Planning Commission

Revised Meeting Agenda

April 13, 2026 | 6:30 PM

Highland Land Planning presented a conceptual plat for Bradshaw Estates at the March 9, 2026, Planning Commission meeting. The proposed development contains a total of 58 single-family residential lots that will be developed in two phases.

DRAWING NO. CP-01

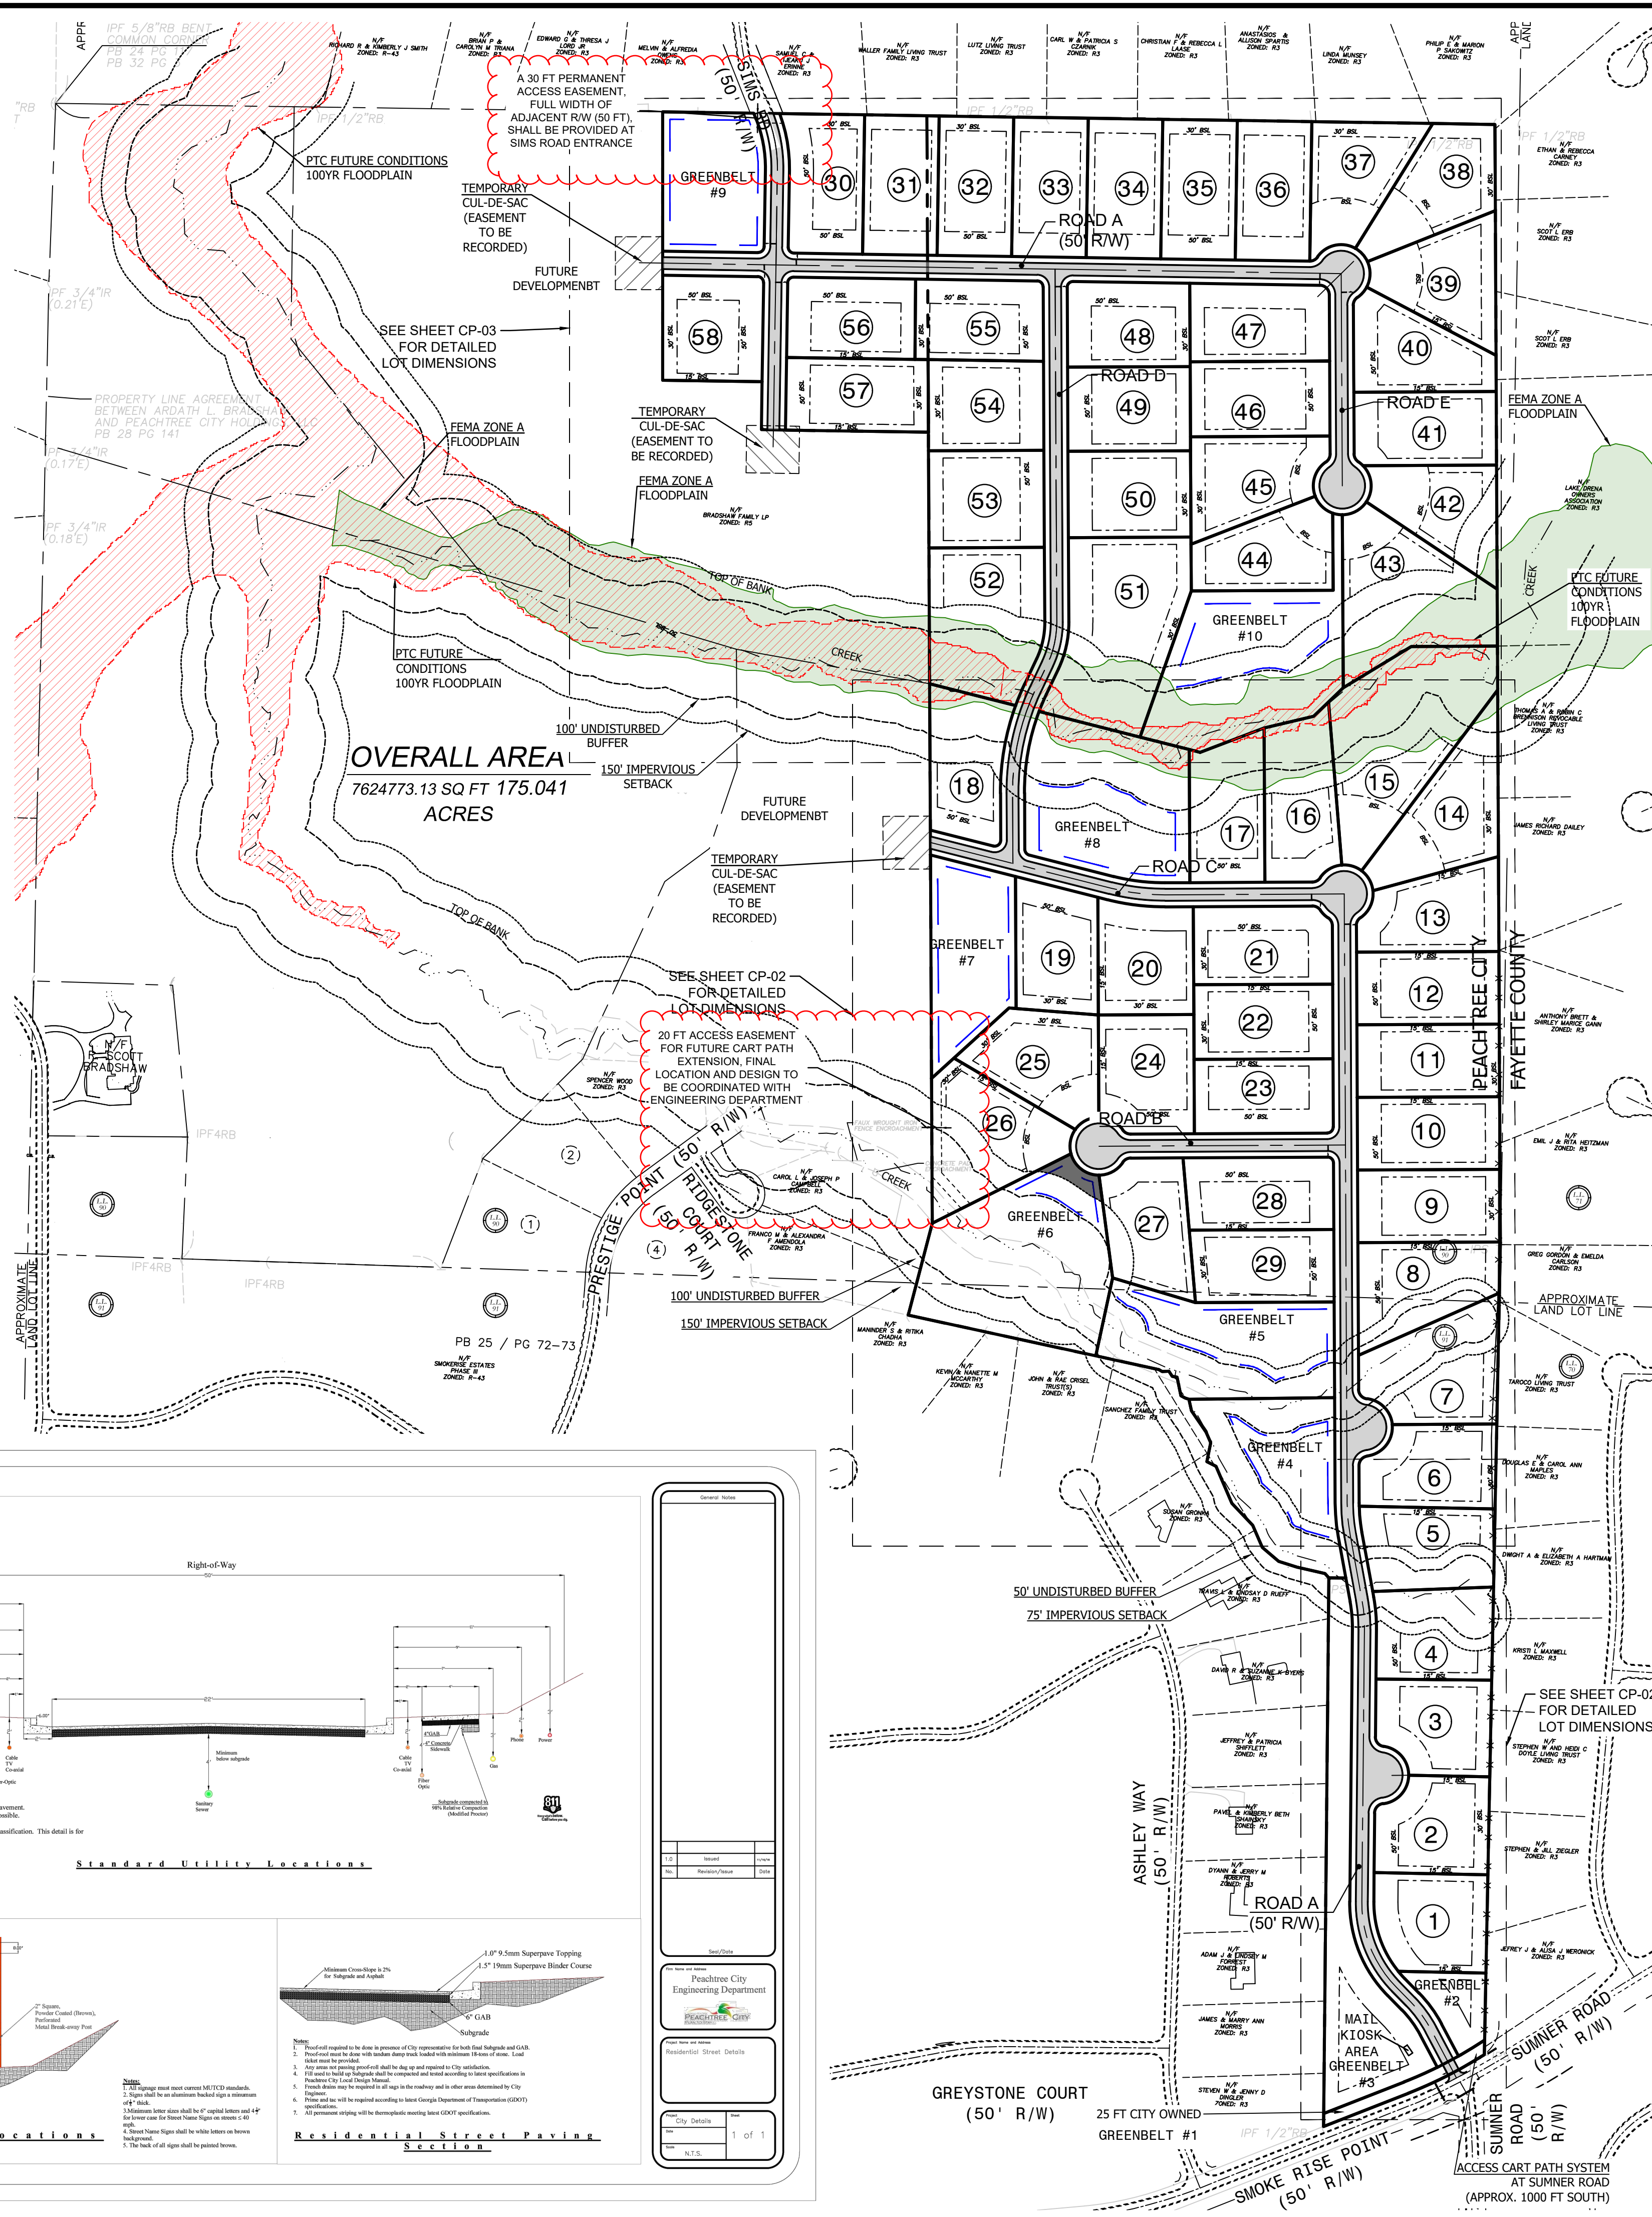
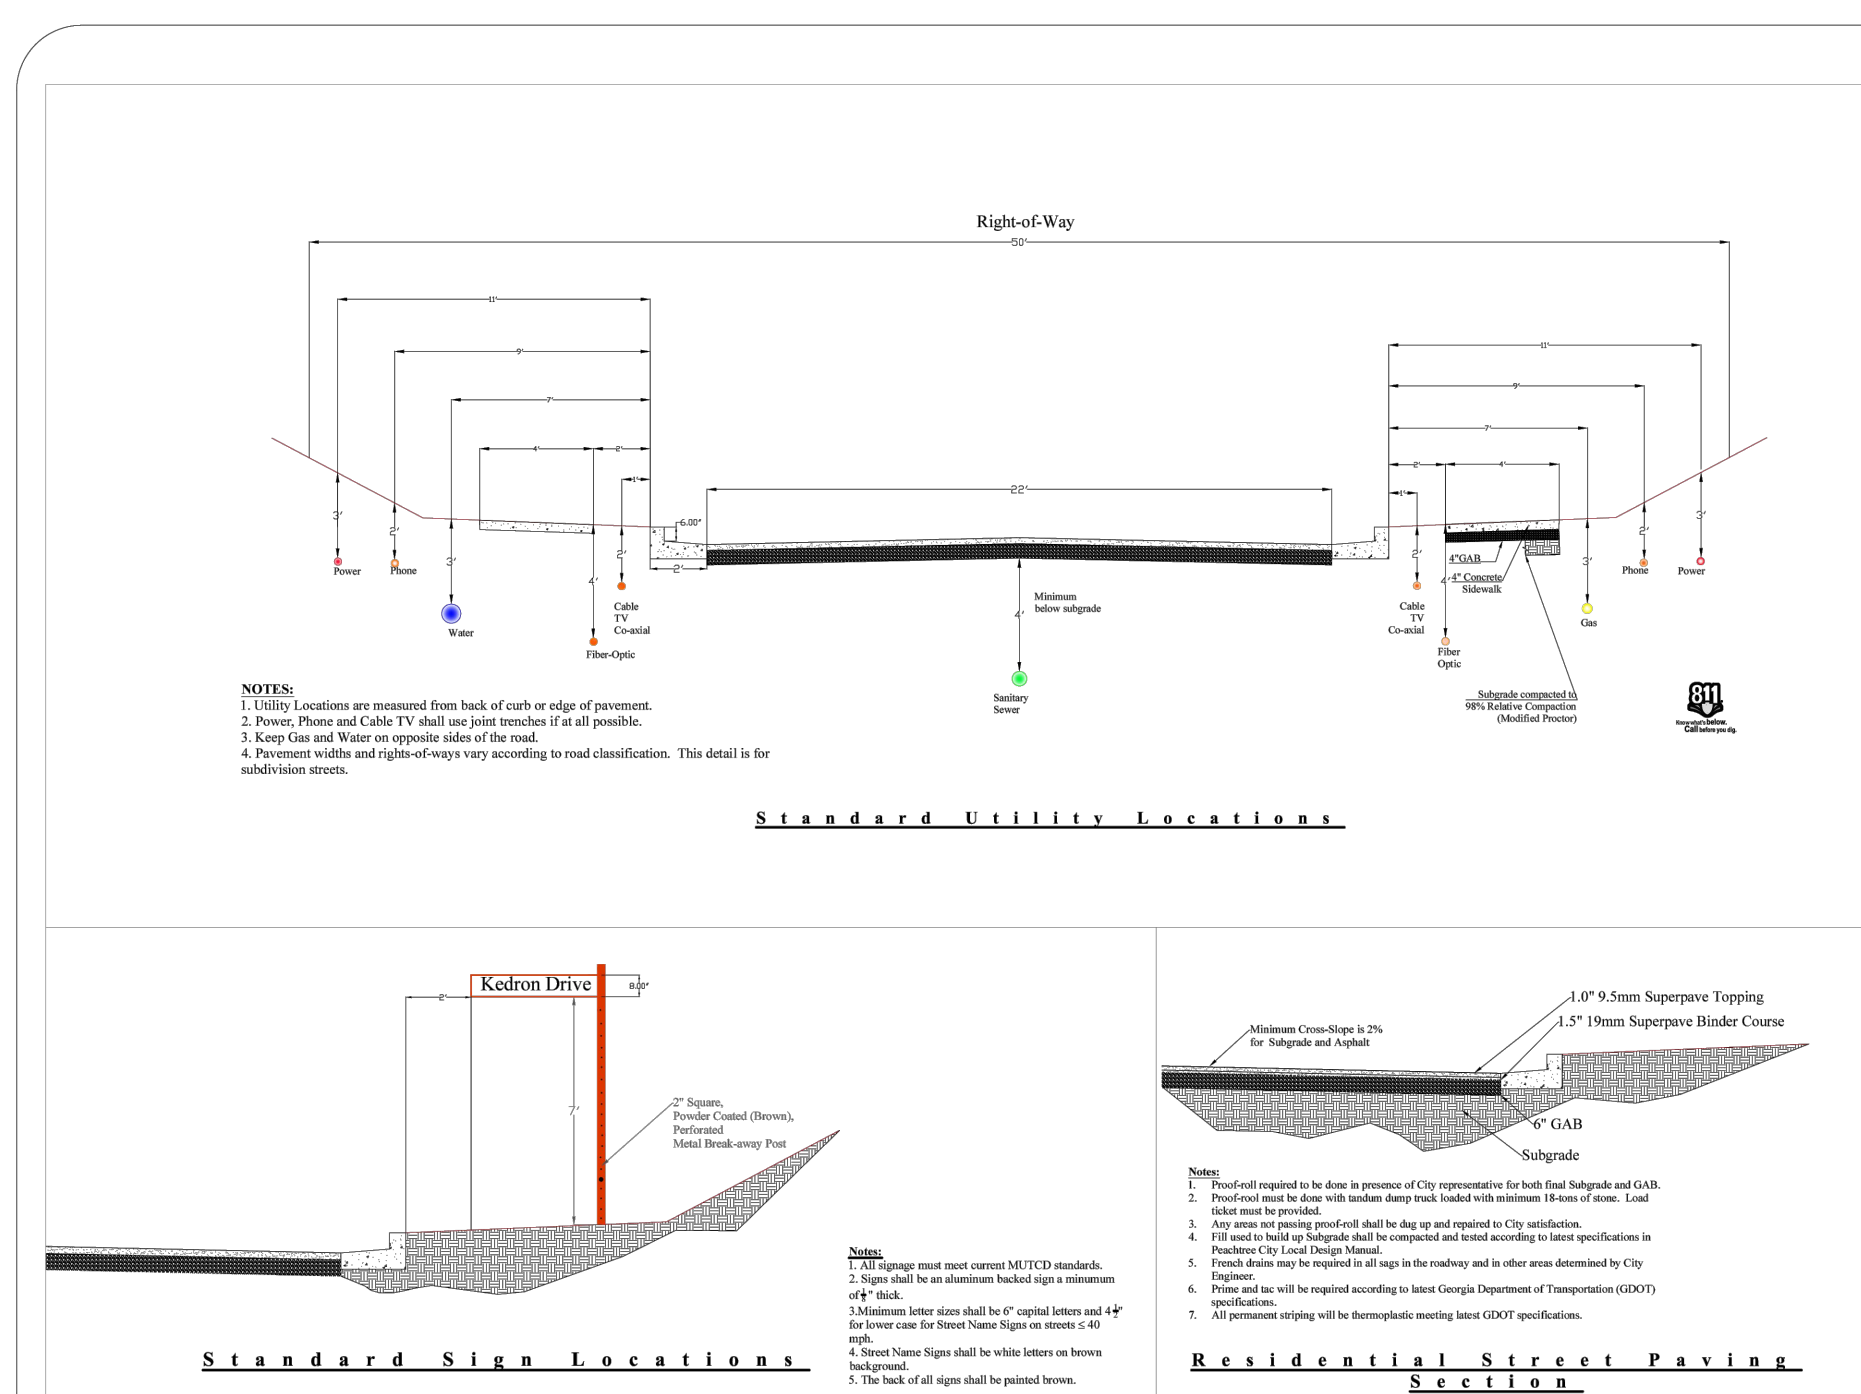
Kriz moved to defer this topic until the first meeting in April. Allen seconded. Ritenour said they were looking at the gate, the cart path connection around the gate, the C.O. for phase 2, which might take care of itself, depending on the gate, the construction traffic management plan, and the plan for path connectivity within the development.

Kriz restated his motion to call for deferral of the conceptual plat for Bradshaw Estates to the April 13 Planning Commission meeting with the following considerations: the gate at Sims Road to Phase 2, cart path connection around the gate, certificate of occupancy delayed until road was constructed—Hooks stopped them to ask what was meant by that, and Hamner clarified it, but they then decided they did not need it if the gate was moved to the north. Kriz completed the motion by asking for a construction traffic management plan and paths within the development. Allen seconded. Motion carried unanimously.

- Provide a gated entrance at Sims Road
- Provide a multi-use path connection around the gate
- Provide a construction traffic management plan
- Consider an internal path system
- Provide an existing traffic study that was prepared for a nearby commercial project for the Commissioners to review

- The developer has agreed to provide a multi-use path connection around the emergency access gate.
- The applicant has added notes to the plan outlining the construction traffic management plan: All construction traffic for all phases of development shall access the property from Sumner Road. All contractors, visitors etc. shall be notified and signage placed as needed.

- After some internal discussions, the City prefers to make the decision about whether to construct paths, IF warranted in the future; the developer shall provide an access easement across the rear of Lot 26 to facilitate potential future path construction and maintenance on the City-controlled greenbelts throughout the subdivision.

- CONSTRUCTION TRAFFIC MANAGEMENT PLAN NOTE:** NO PUBLIC ACCESS IS ALLOWED VIA SIMS ROAD CONNECTION. ALL CONSTRUCTION TRAFFIC FOR EACH PHASE OF DEVELOPMENT AND CONSTRUCTION SHALL ACCESS THE PROPERTY FROM THE SUMNER ROAD ENTRANCE (SOUTHERN ENTRANCE). CARE SHALL BE TAKEN TO NOTIFY AND ADVISE ALL CONTRACTORS, SUBCONTRACTORS, VISITORS, ETC. TO USE THIS ENTRANCE. TRAFFIC MANAGEMENT PLANS PER M.U.T.C.D. SHALL BE PROVIDED, AS NECESSARY.

DRAWING NO. CP-03

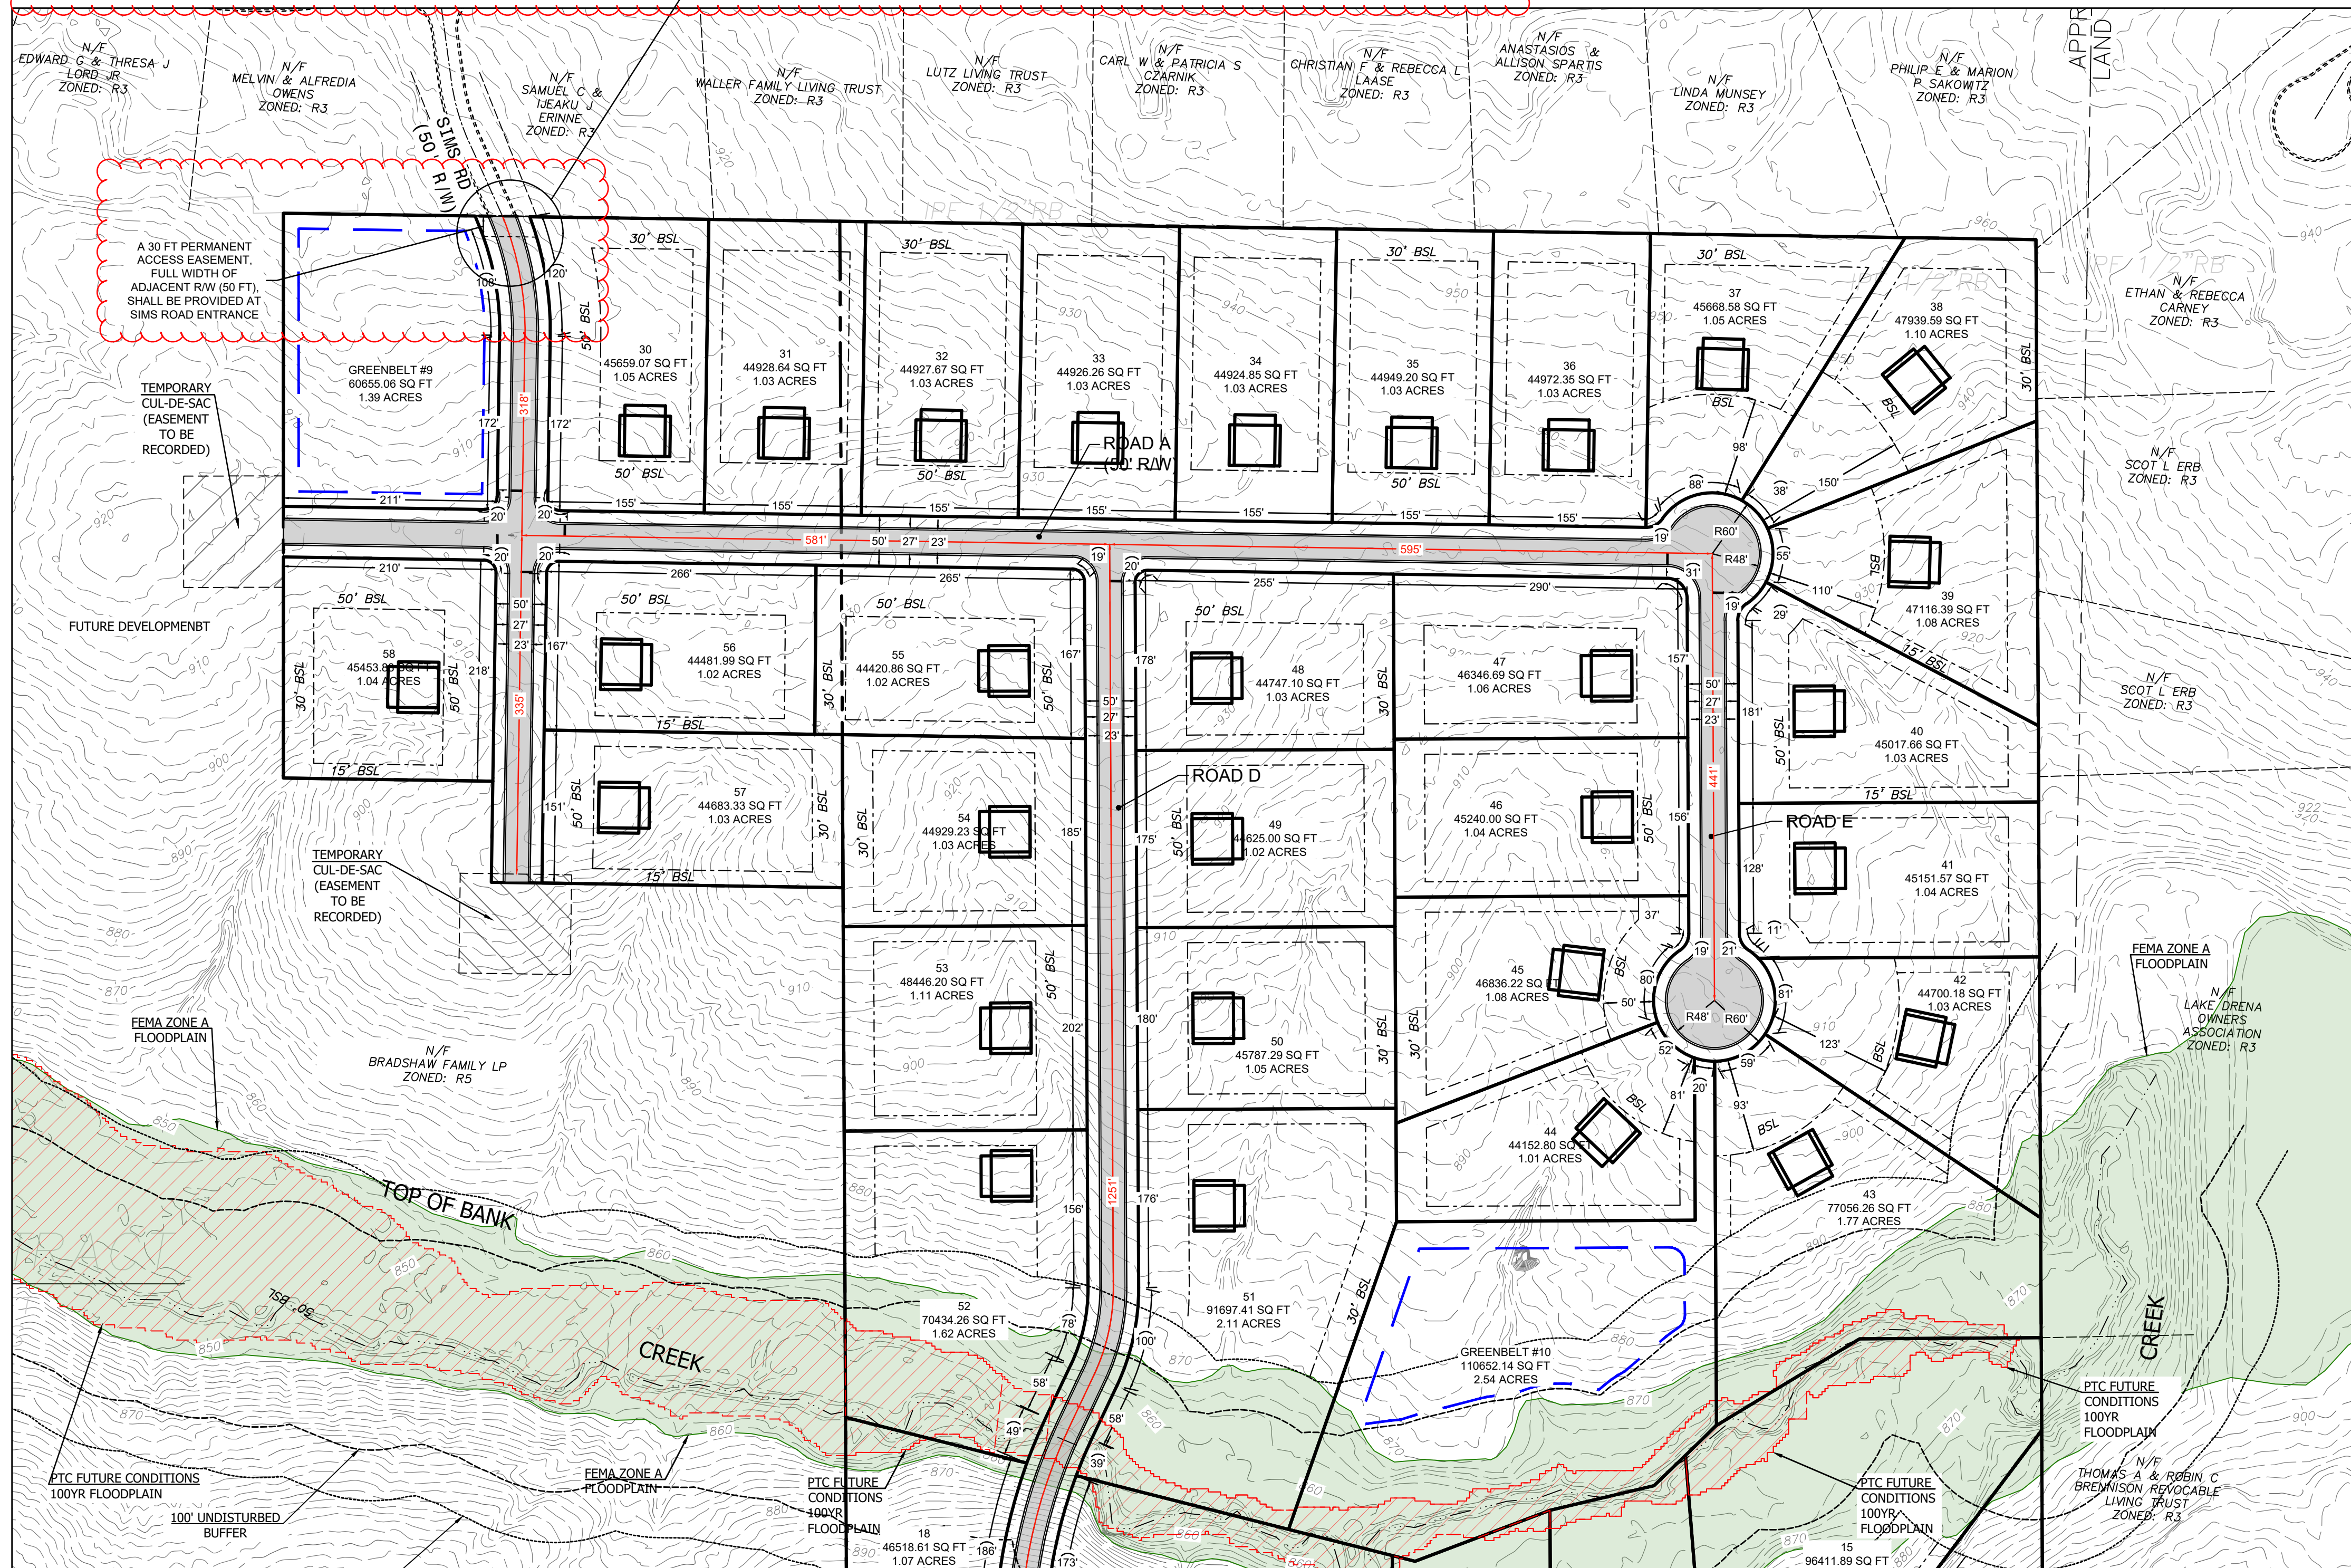
Should the Planning Commission approve the conceptual plat for Bradshaw Estates, Staff has the following recommendations:

3. The developer shall provide a multi-use path easement, a minimum of 20 feet wide, across the rear of Lot 26 for the potential development of a future multi-use path. The developer shall coordinate with the City Engineer to determine the best location for the easement.

EMERGENCY SERVICES ACCESS GATE: BRADSHAW ESTATES WILL PROVIDE AN EMERGENCY SERVICES ACCESS ROAD WITH GATE AT THE SIMS ROAD CONNECTION. A 30 FOOT LONG BY 50 FOOT WIDE SEGMENT OF THIS ROADWAY WILL REMAIN PRIVATE, OWNED BY THE HOMEOWNERS ASSOCIATION WITH A PERMANENT EASEMENT PROVIDED FOR CITY OPERATION AND MAINTENANCE OF THE ACCESS GATE. EASEMENT WILL BE TRANSFERRED VIA THE FINAL PLAT. DEVELOPER SHALL COORDINATE WITH THE CITY ENGINEER AND FIRE MARSHALL REGARDING THE ACCESS ROAD DESIGN AND GATE DESIGN INCLUDING KNOX BOX PROVISIONS. A CART PATH ACCESS AROUND GATE WILL BE PROVIDED FROM SIMS ROAD TO THE EMERGENCY SERVICES ACCESS ROAD.
